Board of Adjustments Called Special Session

Wednesday, December 29, 2021 at 6:30 PM

Re: Bank of America – Manor Commons
SWC Hwy 290 & FM 973
Job No: 20.0003779.000

Alternative Methods of Compliance (AMOC)

SITE GENERAL NOTES:

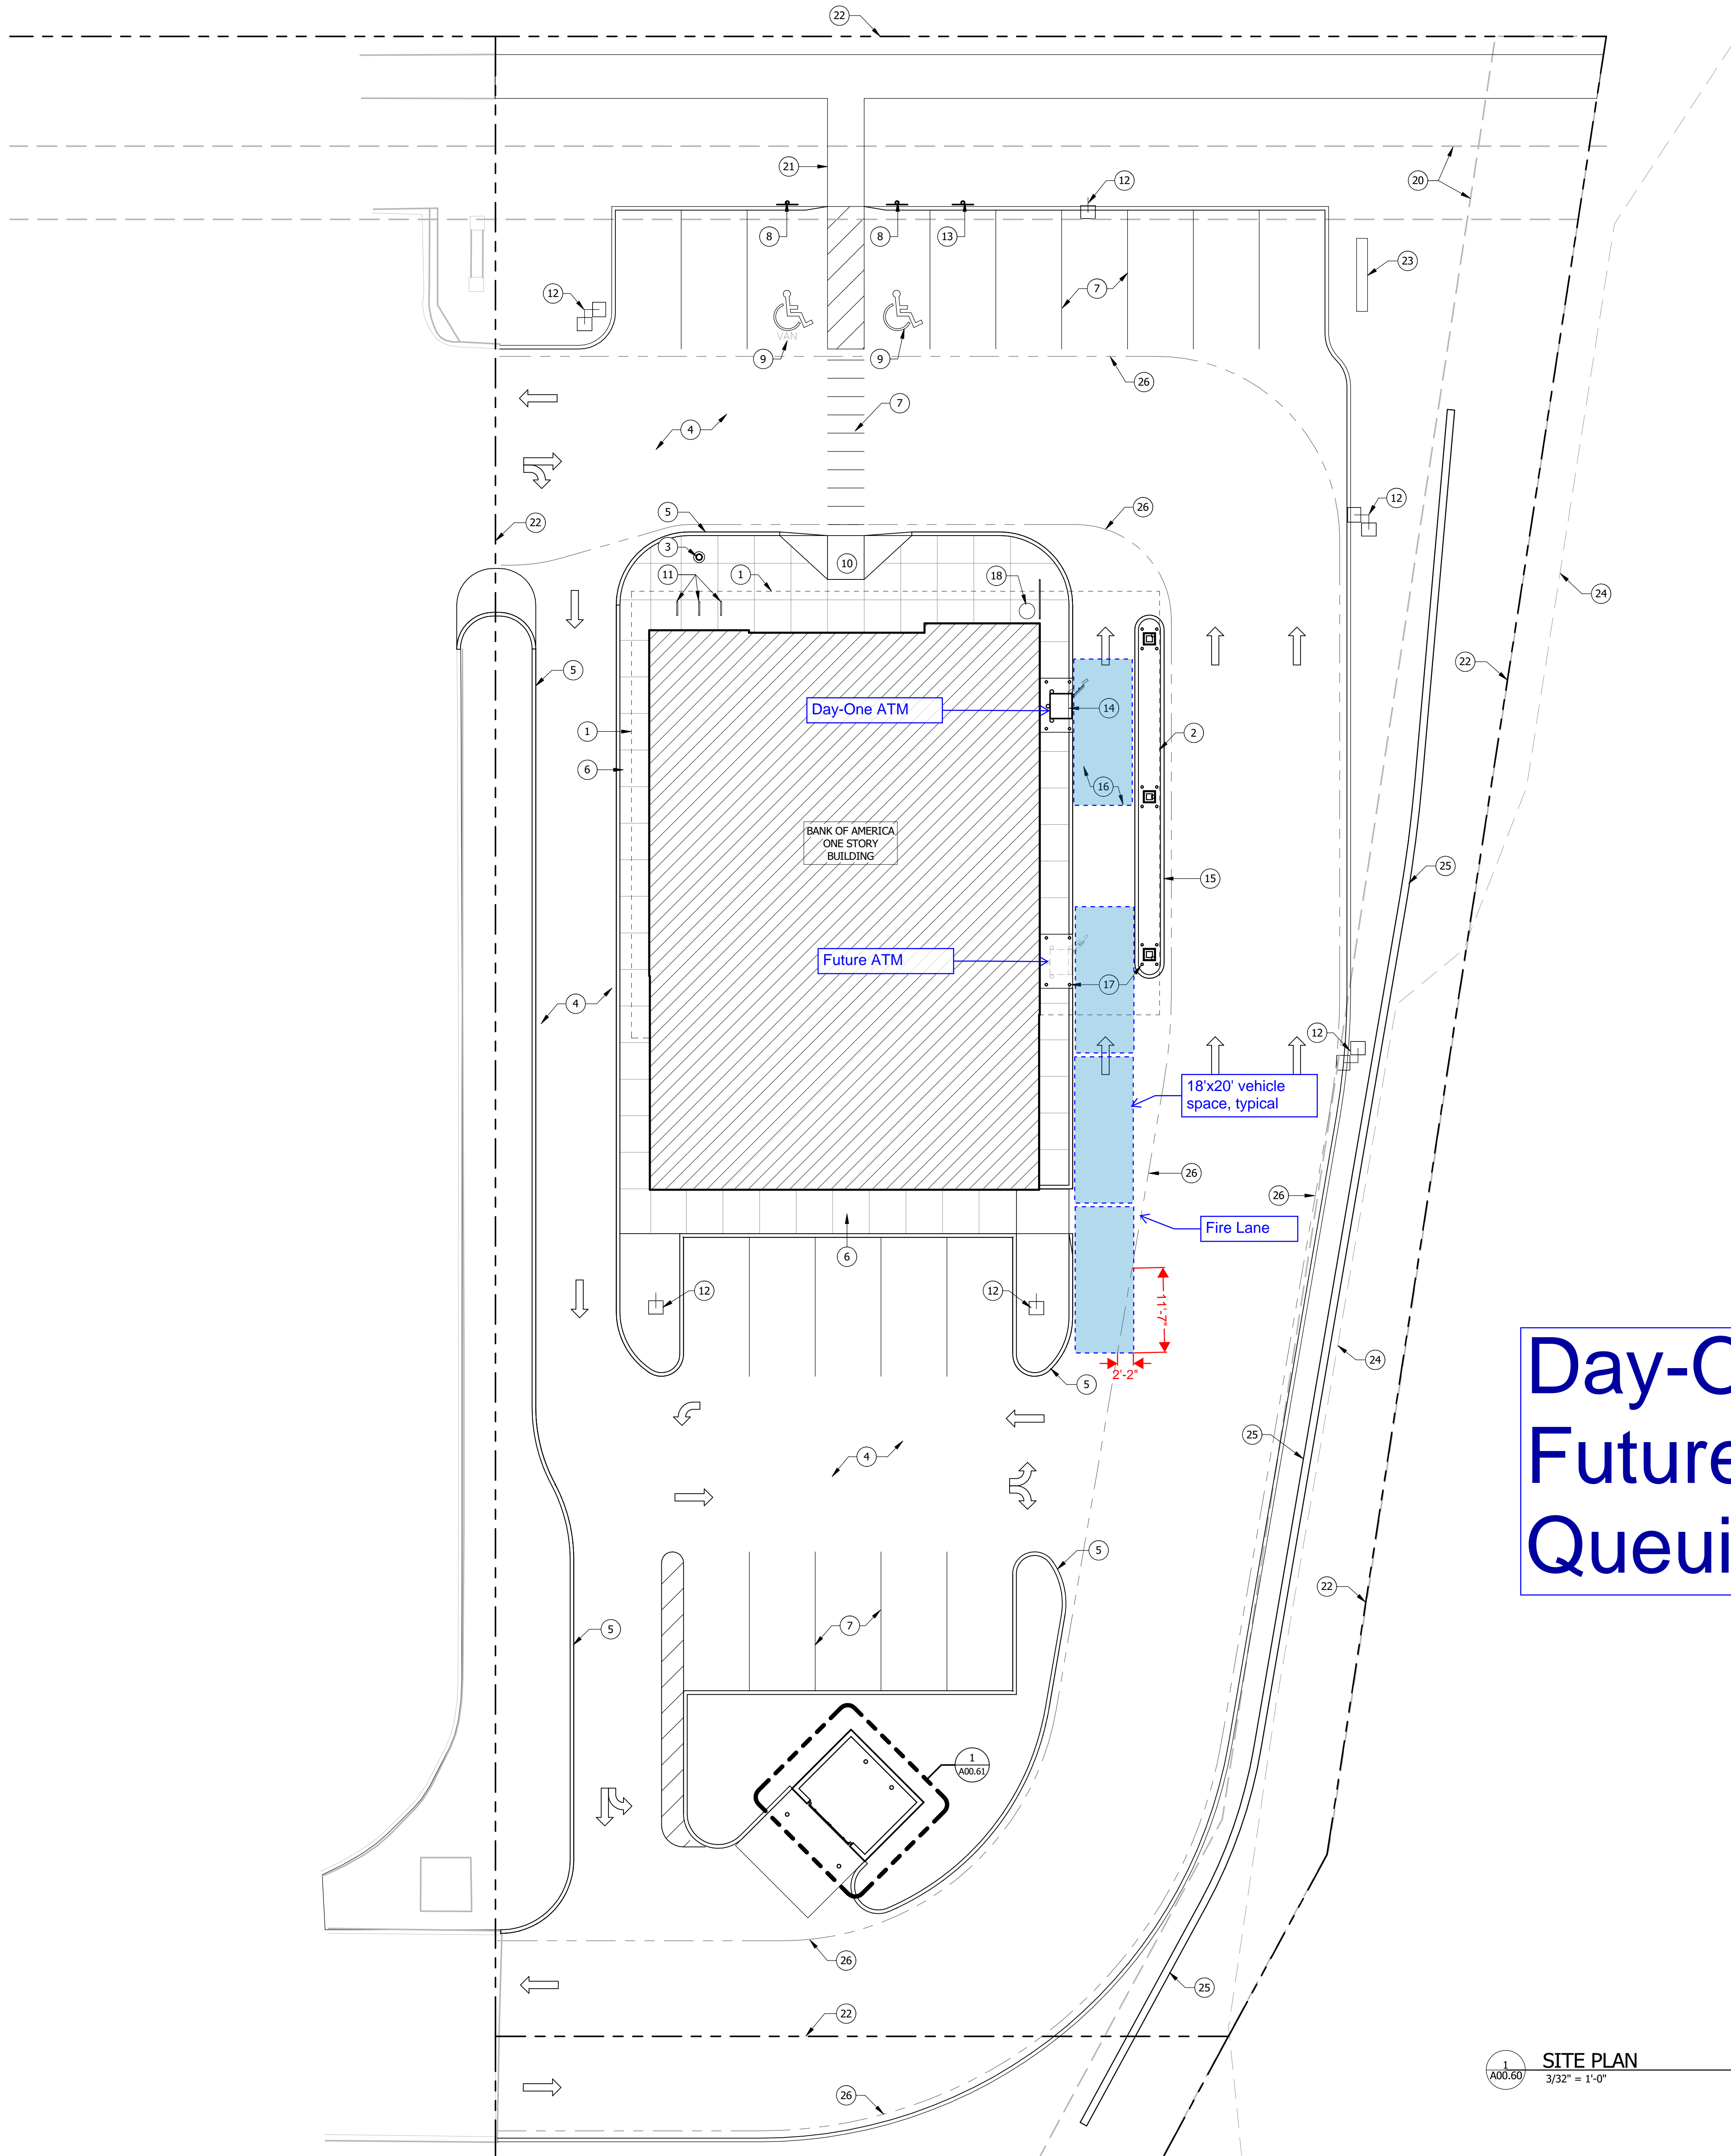
This letter is to ask for your consideration in granting a Planning & Zoning variance, specifically a variance regarding the Manor, Texas Code of Ordinances 09/10/21 Supplement 4, Section 15.02.005 – Queuing requirements. This variance request is only for the proposed future drive-up ATM location. The Day-One ATM location – which will be installed as part of the Bank's primary scope of work and will be available to the public once the Bank's construction is complete – meets the City's queuing requirements and does not require a variance. Diagrams have been uploaded to illustrate the 2 separate ATMs and their queuing.

We request this variance due to the nature of the property tapering to approximately 100', the need for a retaining wall along the east property line and the necessity of providing fire department access around the building. Because of these constraints, our site does not leave sufficient room for the City's minimum 3-car queuing line at the proposed future drive-up ATM without encroaching into the 26-foot wide Fire Lane. We request a variance to allow for a 2-car queuing line at the proposed future drive-up ATM to avoid encroachment into the Fire Lane or allow a third car to encroach into the Fire Lane by 2'-6" for approximately half a car length. If the variance is not granted, the Bank will have its drive-up ATM capacity limited to one ATM. The Bank prefers to have the option to add a second ATM in the future as part of their overall site development strategy. This variance request applies only to the future ATM - the site plan as submitted meets the City's requirement for 3 car queuing at the "day-one" ATM to be installed under the current scope of work.

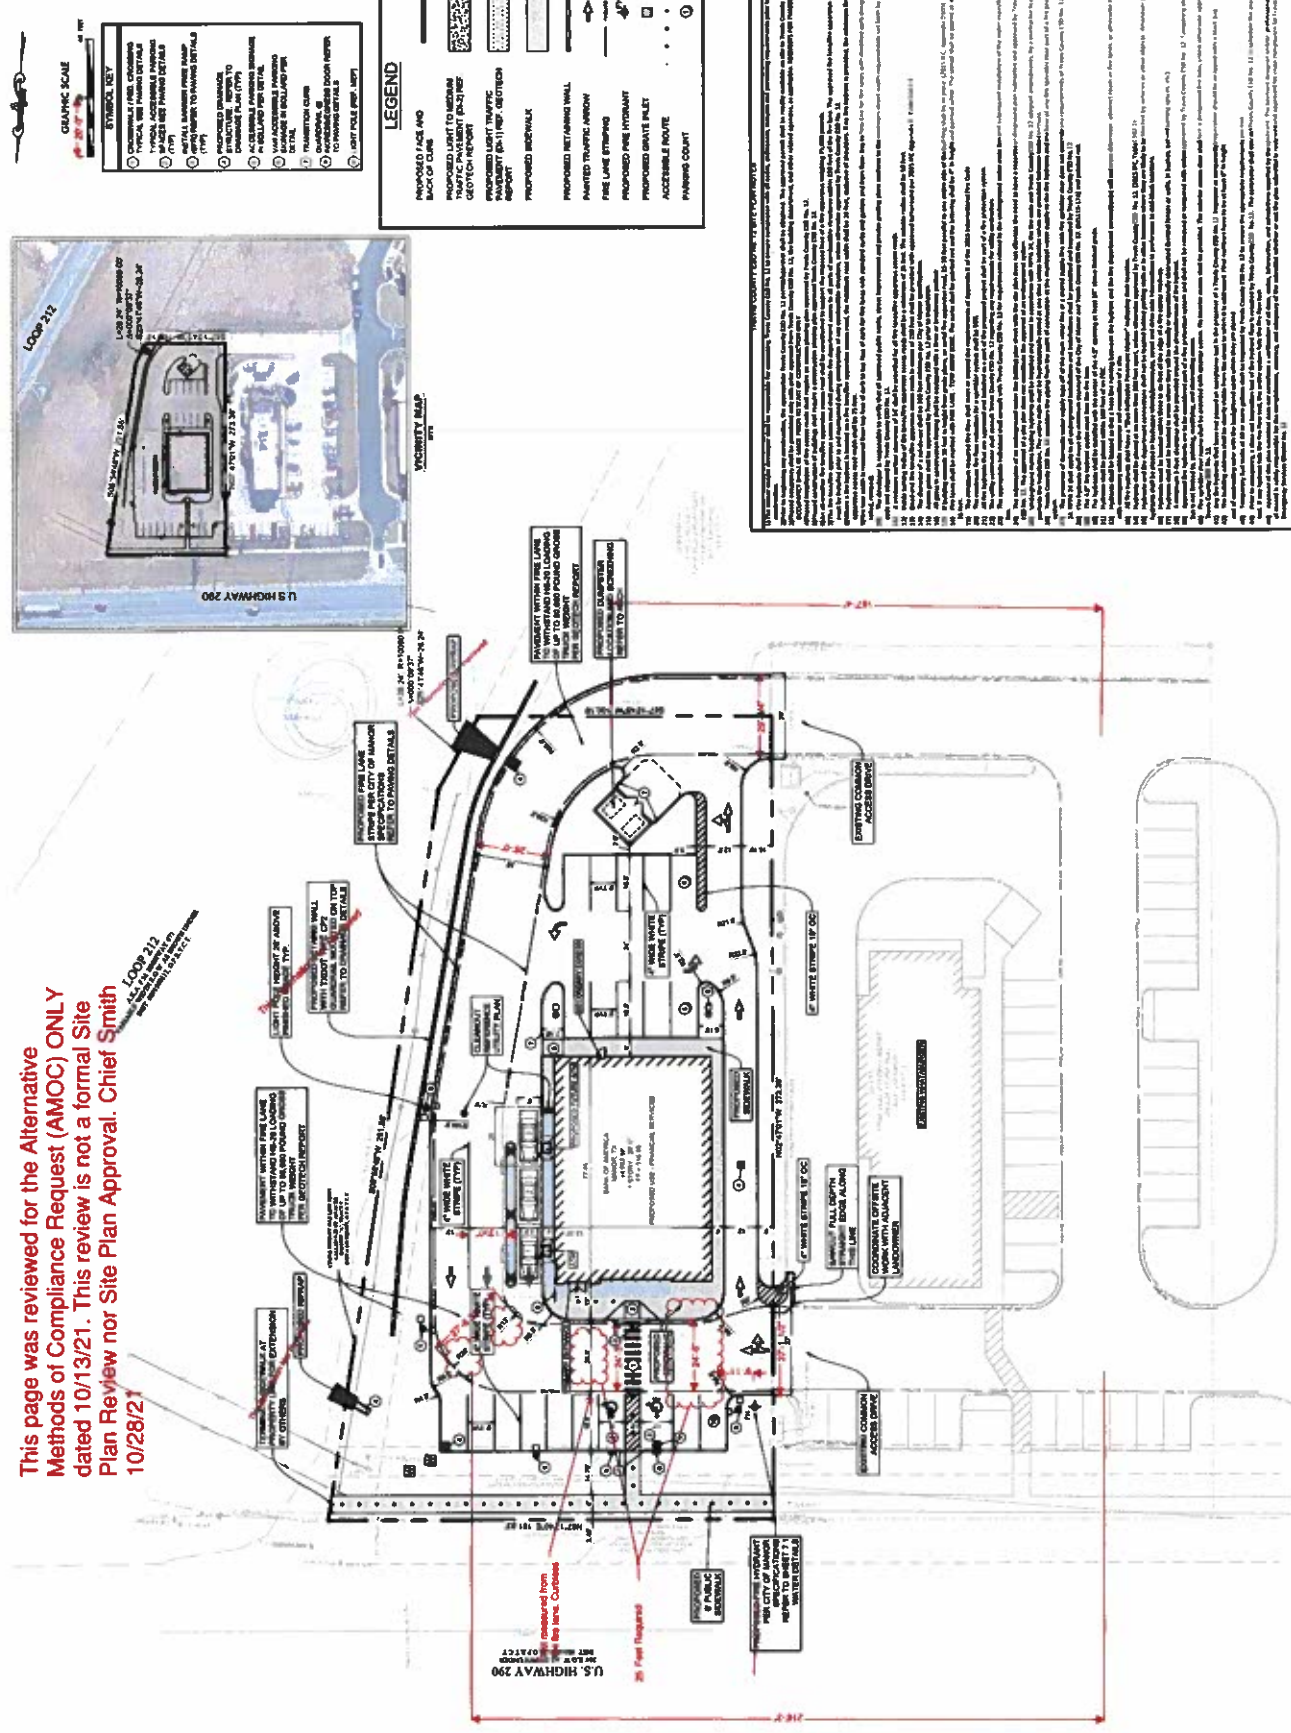
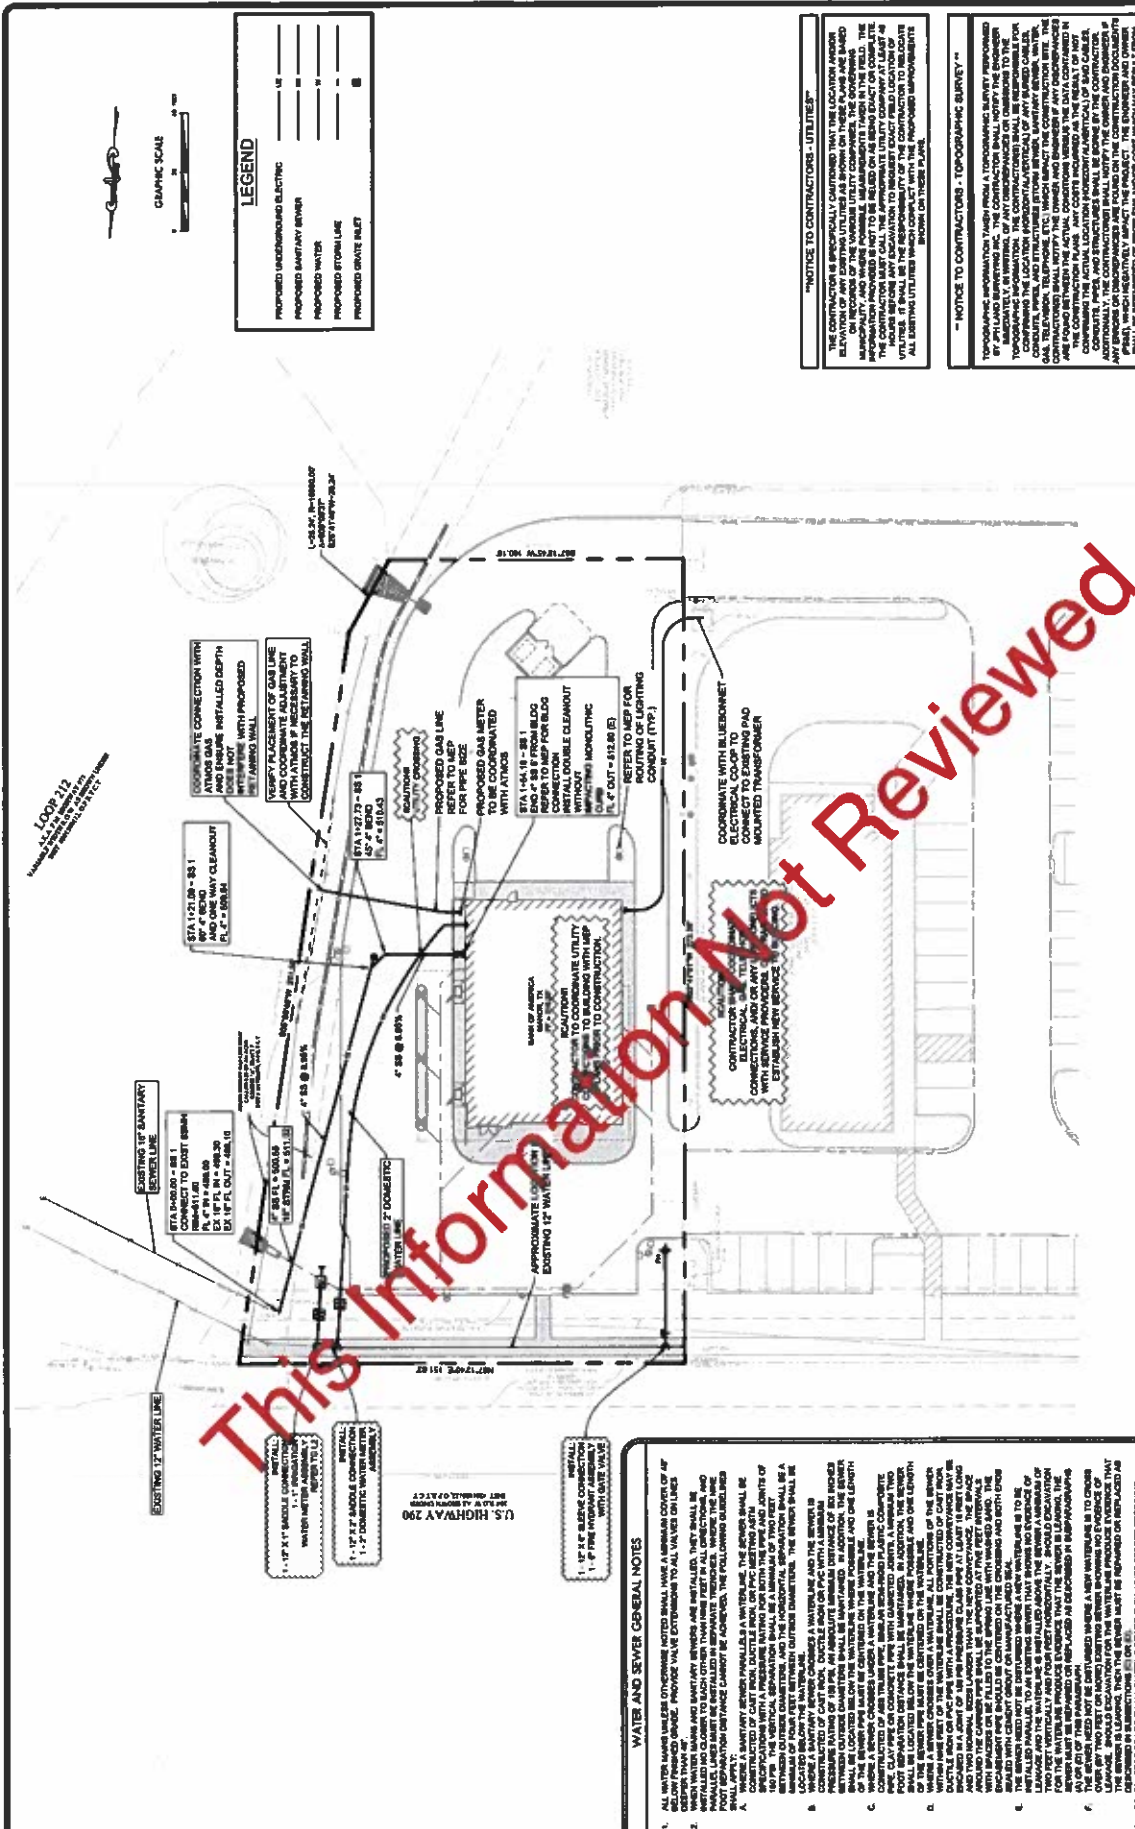
However, we did note that the fire lane width in front of the building is less than the 25 feet as required by code.

- Correct fire lane widths for site plan review.

Bank of America seeks to develop the SW corner lot of Hwy 290 & FM 973. Lot width at the frontage (north) is 151.83 and narrows to 100.18' at the rear (south). Within the lot to the east exists floodplain and an 8" gas easement. What-a-burger exists to the west.

✓ AMOC #1 - Inside firelane radius at the NE corner of the building is 13' (25' req.) Outside radius has been increased to 25' (50' req.) for a firelane radial width in excess of 25' (29'-6" provided w/o FH).

AMOC #2 - City requires an ATM to provide queuing for three (8' x 20') cars. This third car at the southern ATM reduces the clear firelane to 23' (25' req.)

NOT REVIEWED

Amoc #1 Reviewed Only

This page was reviewed for the Alternative Methods of Compliance Request (AMOC) ONLY dated 10/13/21. This review is not a formal Site Plan Review nor Site Plan Approval. Chief Smith 10/28/21

SITE PLAN

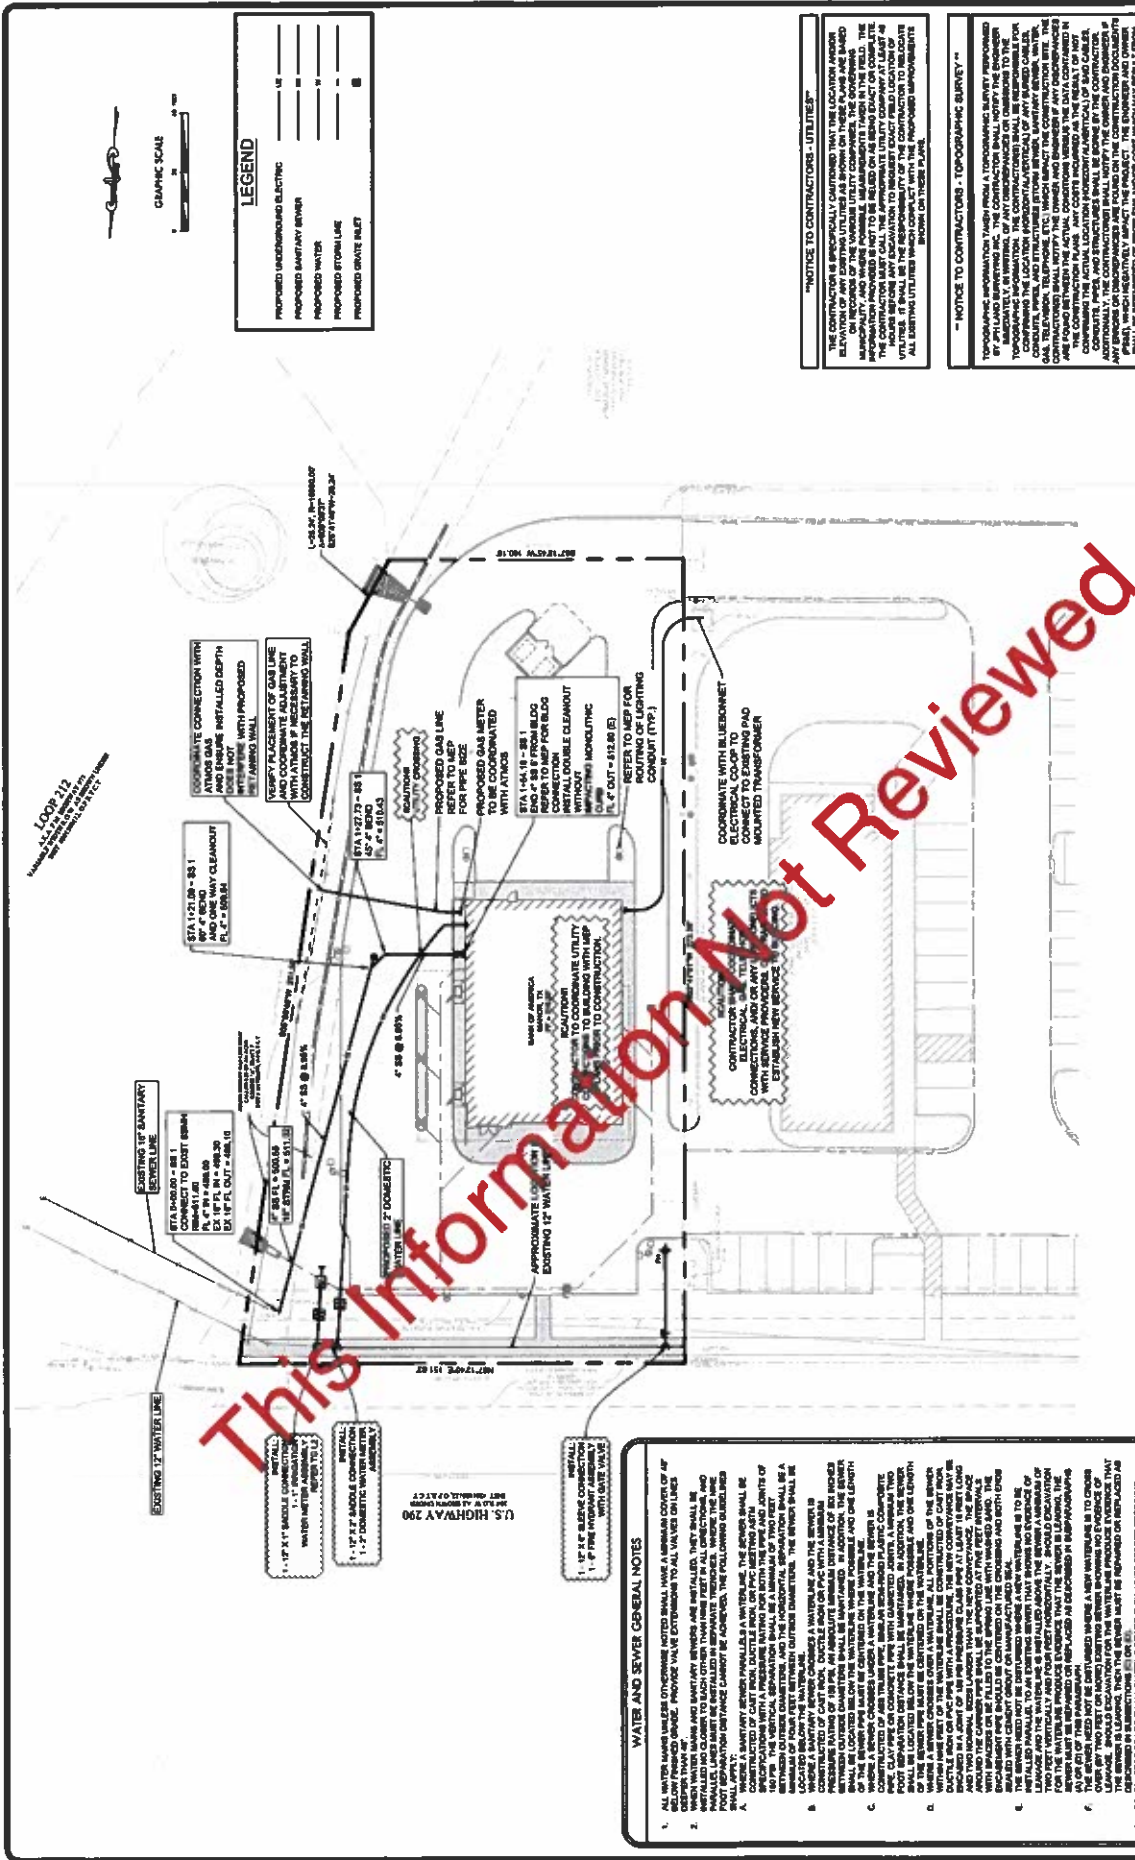
AMOC #2 - City requires an ATM to provide queuing for three (8' x 20') cars. This third car at the southern ATM reduces the clear firelane to 23' (25' req.)

- Correct fire lane widths for site plan review.

This page was reviewed for the Alternative Methods of Compliance Request (AMOC) ONLY dated 10/13/21. This review is not a formal Site Plan Review nor Site Plan Approval. Chief Smith 10/28/21
